PRODUCT INFORMATION NOTIFICATION

PIN: PIN194402

Subject: Qualification of New Carrier Tape for Select QFN Packages at Cypress Philippines

**Qualification of Kostat Carrier Tape
QFN 4x4 / QFN 5x5 / QFN 6x6 Package
CML-Philippines (RA/R)**

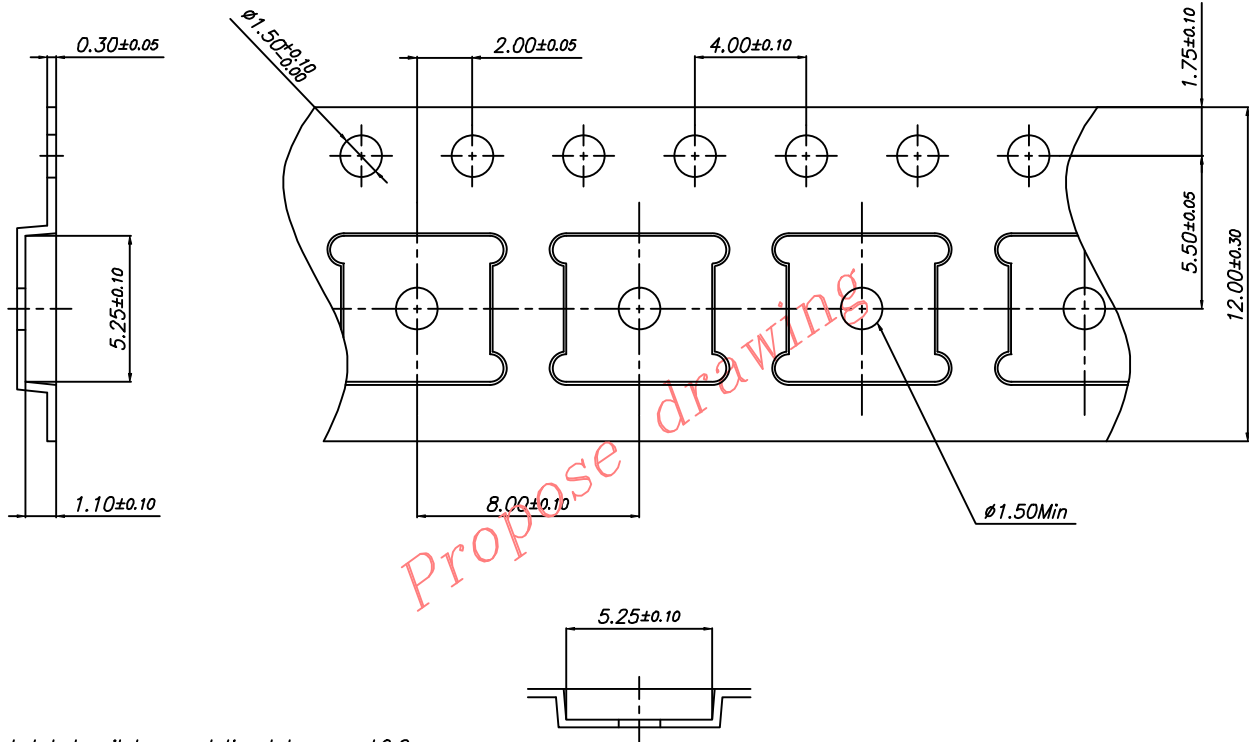
Cypress has qualified an EIA standard carrier tape for select QFN packages at Cypress Philippines (CML, Gateway Business Park, SEPZA, Brgy., Javalera, General Trias, Cavite, Philippines). The new carrier tape meets the Cypress specification and demonstrates the same quality as the current carrier tape being used.

Package	Critical Dimension	Current: ADVANTEK / CPAK		Proposed: KOSTAT		Remarks
		Dim (mm)	Tol (mm)	Dim (mm)	Tol (mm)	
QFN 6X6mm	Tape Width (W)	16.00	0.3	16.00	0.3	Matched
	Pocket Width (Ao)	6.30	0.1	6.30	0.1	
	Pocket Length (Bo)	6.30	0.1	6.30	0.1	
	Pocket Depth (Ko)	0.80	0.1	0.80	0.1	
	Pocket Pitch	12.00	0.1	12.00	0.1	
	Sprocket hole Pitch	2.00	0.1	2.00	0.1	
	Sprocket hole Diameter	1.50	0.1	1.50	0.1	
	Center Hole Diameter	1.5min	NA	1.5min	NA	
Color	Black		Black

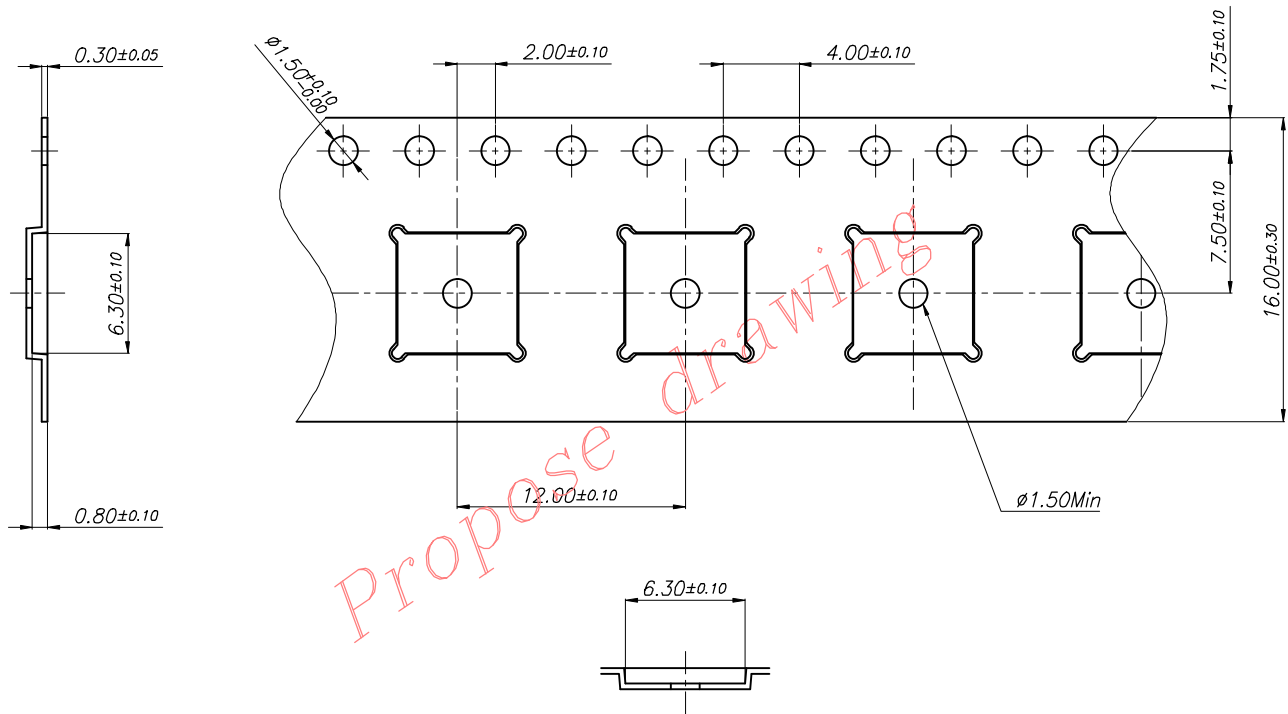
Package	Critical Dimension	Current: ADVANTEK / CPAK		Proposed: KOSTAT		Remarks
QFN 5X5mm	Tape Width (W)	12.00	0.3	12.00	0.3	Matched
	Pocket Width (Ao)	5.25	0.1	5.25	0.1	
	Pocket Length (Bo)	5.25	0.1	5.25	0.1	
	Pocket Depth (Ko)	1.10	0.1	1.10	0.1	
	Pocket Pitch	8.00	0.1	8.00	0.1	
	Sprocket hole Pitch	4.00	0.1	4.00	0.1	
	Sprocket hole Diameter	1.50	0.1	1.50	0.1	
	Center Hole Diameter	1.5min	NA	1.5min	NA	
	Color	Black		Black		
QFN 4X4mm	Tape Width (W)	12.00	0.3	12.00	0.3	Matched
	Pocket Width (Ao)	4.30	0.1	4.30	0.1	
	Pocket Length (Bo)	4.30	0.1	4.30	0.1	
	Pocket Depth (Ko)	1.10	0.1	1.10	0.1	
	Pocket Pitch	8.00	0.1	8.00	0.1	
	Sprocket hole Pitch	4.00	0.1	4.00	0.1	
	Sprocket hole Diameter	1.50	0.1	1.50	0.1	
	Center Hole Diameter	1.5min	NA	1.5min	NA	
	Color	Black		Black
